International Aero Engines

SERVICE BULLETIN

<u>ENGINE - FUEL AND CONTROL - DEDICATED ALTERNATOR STATOR - INTRODUCTION OF NEW SOURCE OF</u>
SUPPLY - CATEGORY CODE 7 - MOD.ENG-73-0070

V2500-ENG-73-0070

LOCATION OF DEDICATED ALTERNATOR STATOR Fig.1

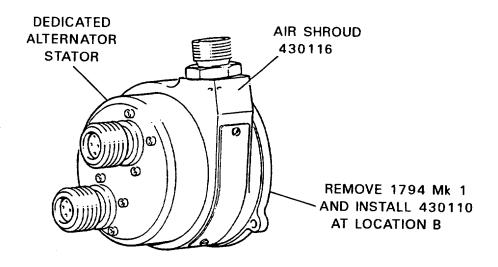
Incorporation of this Service Bulletin is designed to introduce a new source of supply for the Engine Dedicated Alternator Stator.

B.F. Goodrich (B.F.G.) has been chosen as the new unit supplier. The B.F.G. stator introduced by this Service Bulletin is completely interchangeable with the current units.

The shroud for the new stator unit is a separate item and can be located on the stator unit in one of two positions, dependent on the engine model application: Position 1 for A1/A5 engines and Position 2 for D5 engines.

- (1) This Bulletin covers the introduction of a new Engine Dedicated Alternator Stator supplied by B.F. Goodrich.
- (2) Units introduced by this Bulletin will be identified by the type number 430116 shroud and 430110 stator.

- C. Assembly Instructions
 - (1) Install the new 430116 Air Shroud to the 430110 Dedicated Alternator Stator by inserting shroud dowel into hole position 2 of the stator, install assembly as instructed in the MD90 Engine Manual, TASK 72-00-60-450-001.
- D. Recording Instructions
 - (1) A record of accomplishment is necessary.
